Belsay Awakes Play Layout  
- Annotated Changes

BY  
WH/TH

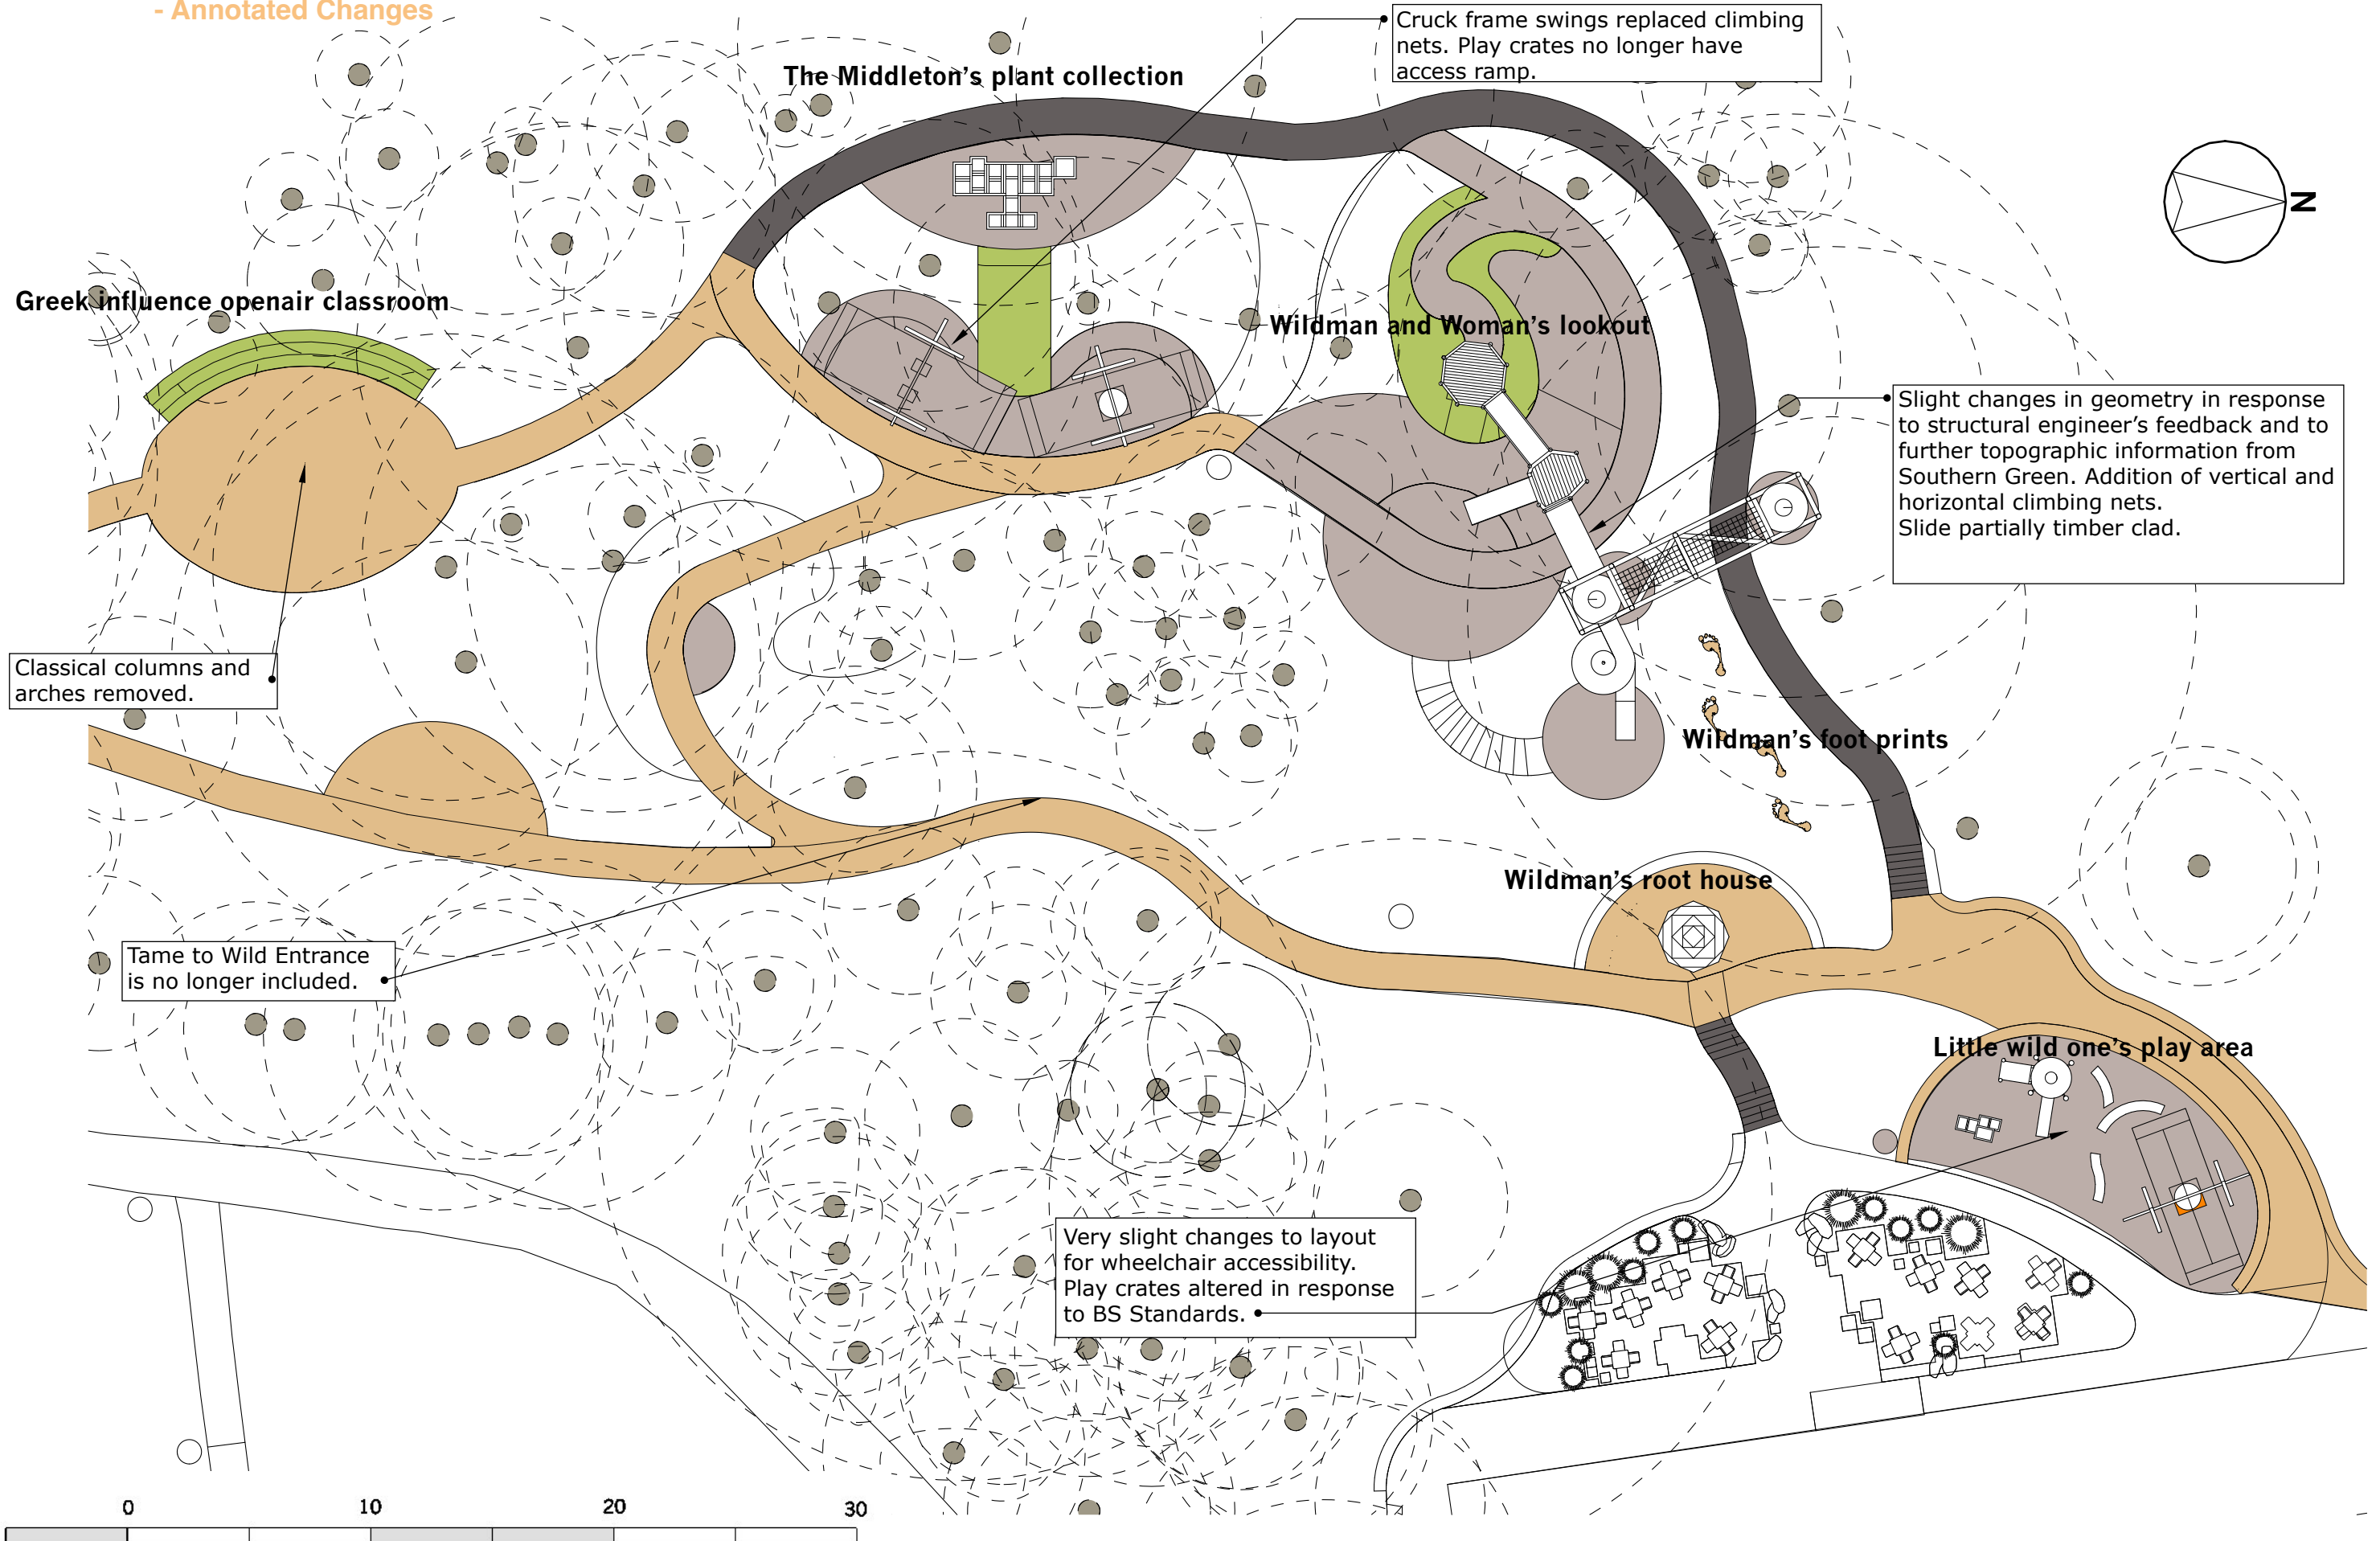
Cruck frame swings replaced climbing nets. Play crates no longer have access ramp.

Slight changes in geometry in response to structural engineer's feedback and to further topographic information from Southern Green. Addition of vertical and horizontal climbing nets. Slide partially timber clad.

Classical columns and arches removed.

Tame to Wild Entrance is no longer included.

Very slight changes to layout for wheelchair accessibility. Play crates altered in response to BS Standards.
